Kings Beach State Recreation Area

Preliminary General Plan Revision and
Final Environmental Impact Report/
Kings Beach Pier Rebuild Project Final
Environmental Impact Report/
Environmental Impact Statement

Preliminary General Plan Revision and Final Environmental Impact Report/Kings Beach Pier Rebuild Project Final Environmental Impact Report/ Environmental Impact Statement

Chapter 2, Responses to Comments, contains a list of all parties who submitted comments on the Draft EIR/EIS during the public review period, copies of the comment letters received, a copy of the comment summaries from the June 2018 public hearings, and responses to the comments.

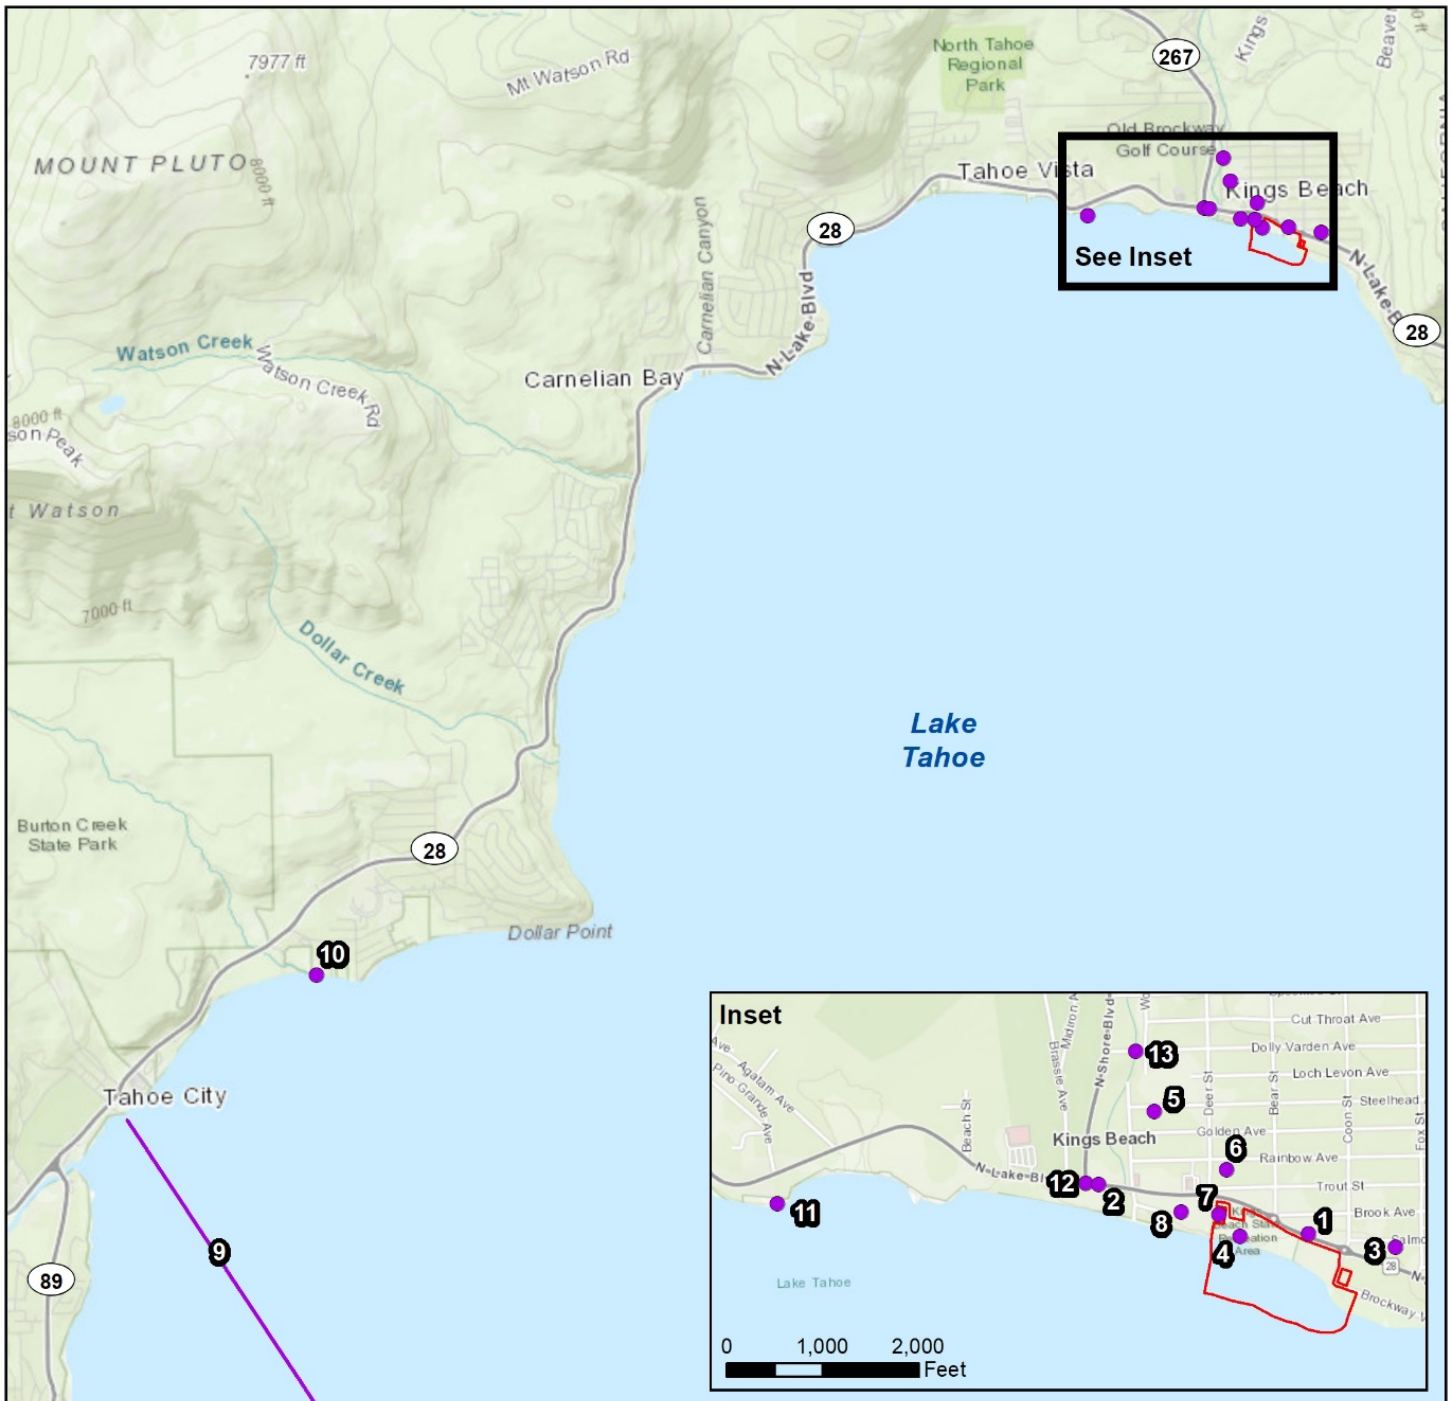
- 2-4 The comment requests that the Lakeside Redevelopment project at 8200 North Lake Boulevard and the Kings Beach Center project located at 8675 North Lake Boulevard be included in the cumulative impacts project list in Table 5.1-4 of the Draft EIR/EIS. The Kings Beach Center project is included in Table 5.1-4 as the Kings Beach Center Design Concept. It is assumed that the proposed Kings Beach Center project would be consistent with the land uses and maximum development potential considered as part of

In response to this comment, portions of Table 5.1-4 beginning on 5-32 and Exhibit 5.1-15 on page 5-36 of the Draft EIR/EIS are revised as follows:

13-6

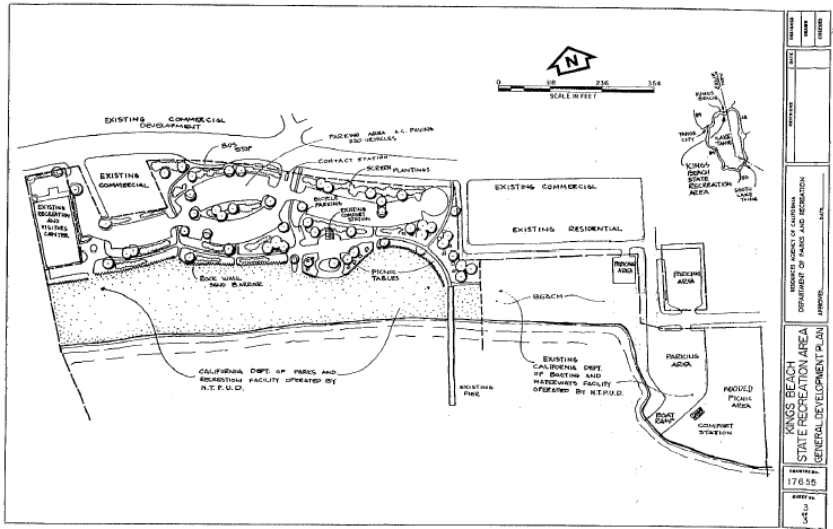
7). The environmental documentation must include the three maps below and must be updated to reflect what is on the ground today as well as what is being proposed as part of this project

13-9

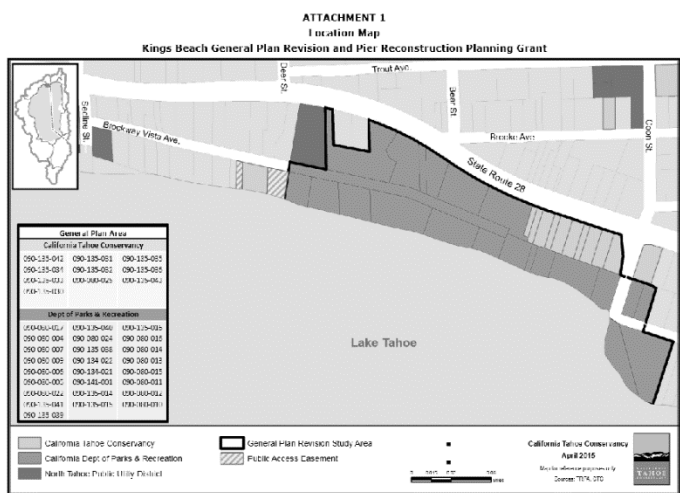
13). What does the 13.91 acres encompass and are proposed changes going to be addressed as part of this Project? And how does the KB Charette Vision align with the alternatives?

13-11

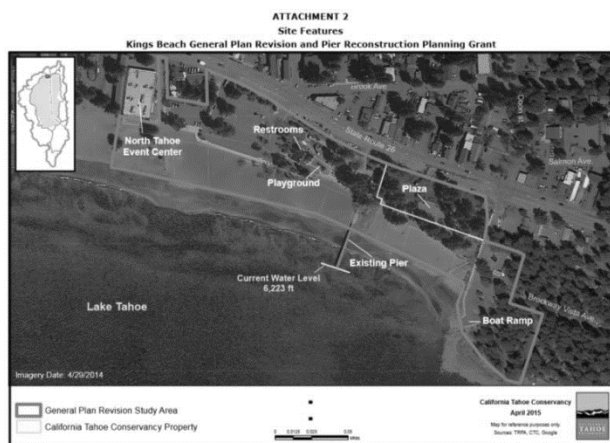
16). The environmental documentation must include the map below showing the proposed project boundaries.

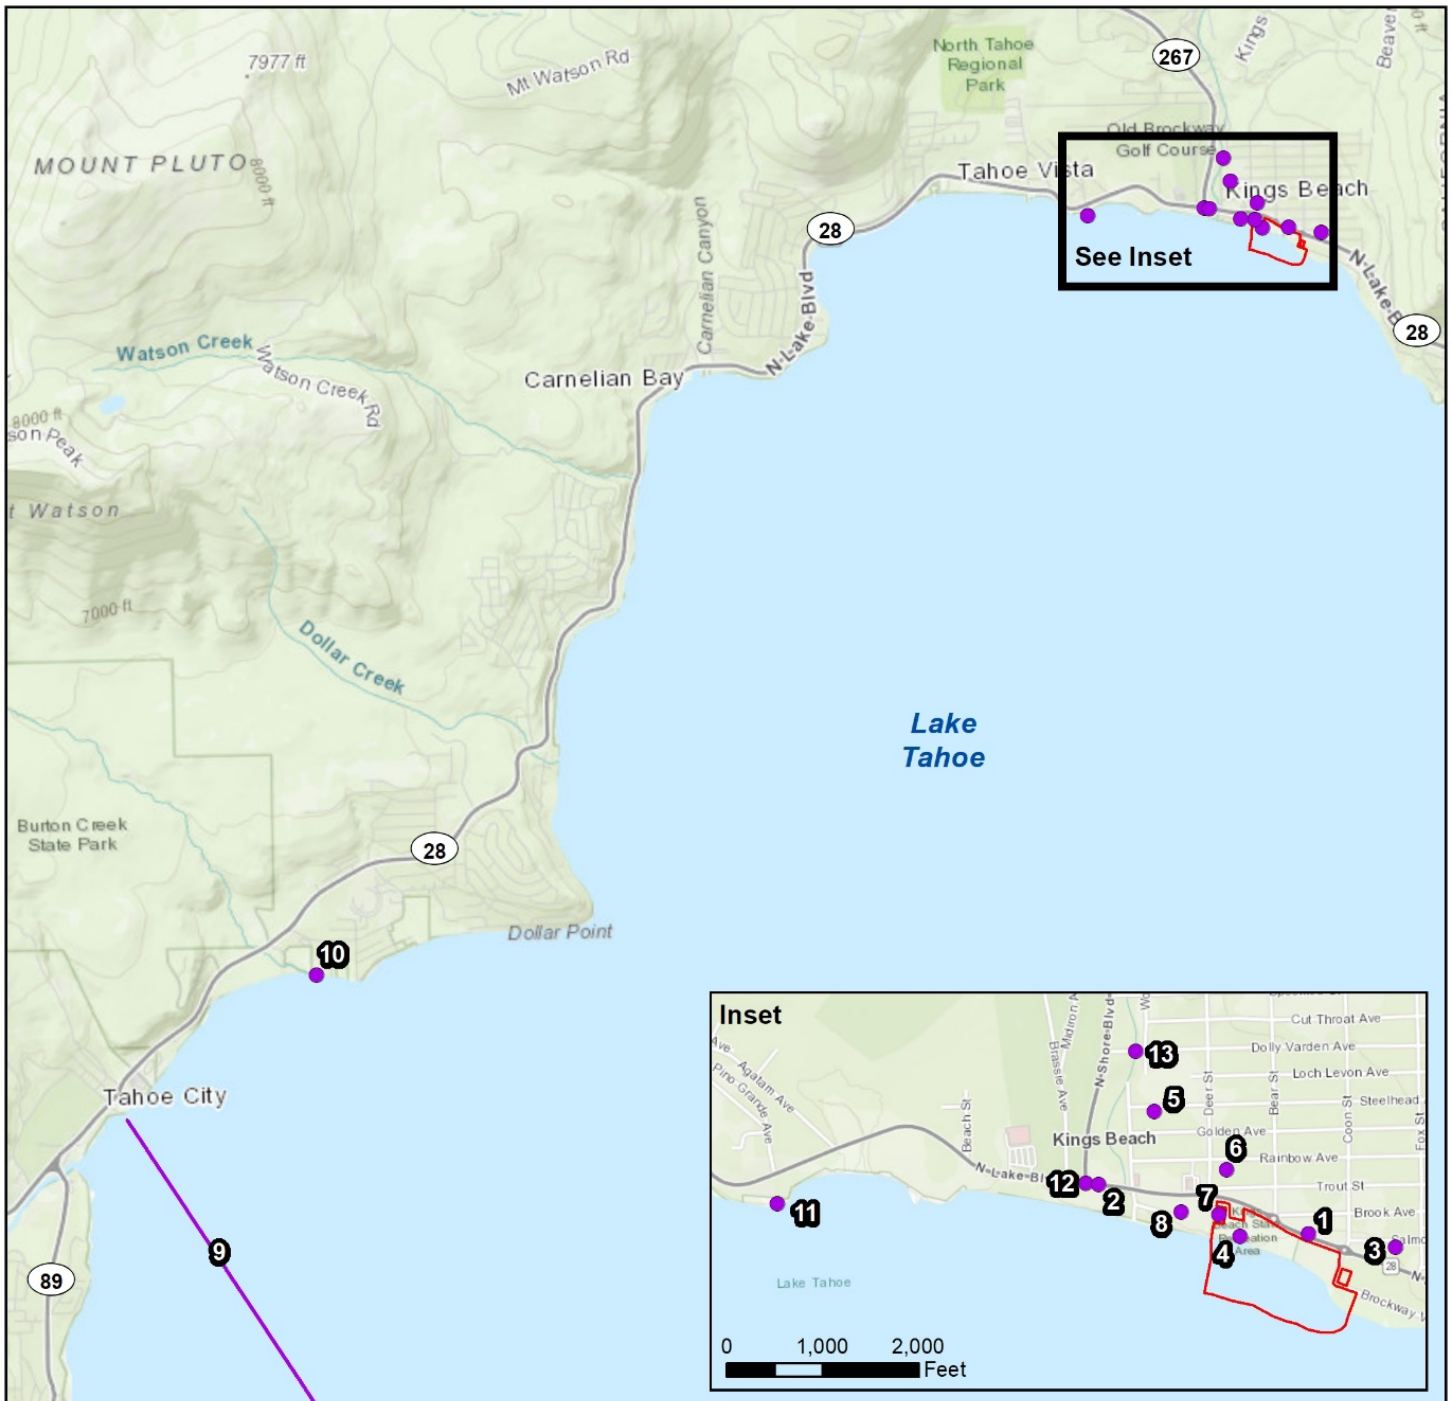
- 12-3 The comment requests that the cumulative impact analysis consider nearby projects as well as Kings Beach specific projects to accurately and adequately assess environmental impacts. Table 5.1-4 and Exhibit 5.1-15 in the Draft EIR/EIS identify projects within Kings Beach and those most likely to contribute to cumulative impacts. Redevelopment of the Crown Motel (i.e., the Lakeside Redevelopment Project) is addressed in response to comment 2-4.

Portions of Table 5.1-4 beginning on page 5-32 and Exhibit 5.1-15 on page 5-36 in Section 5.1.3, Contents of Environmental Analysis Sections, are revised as follows:
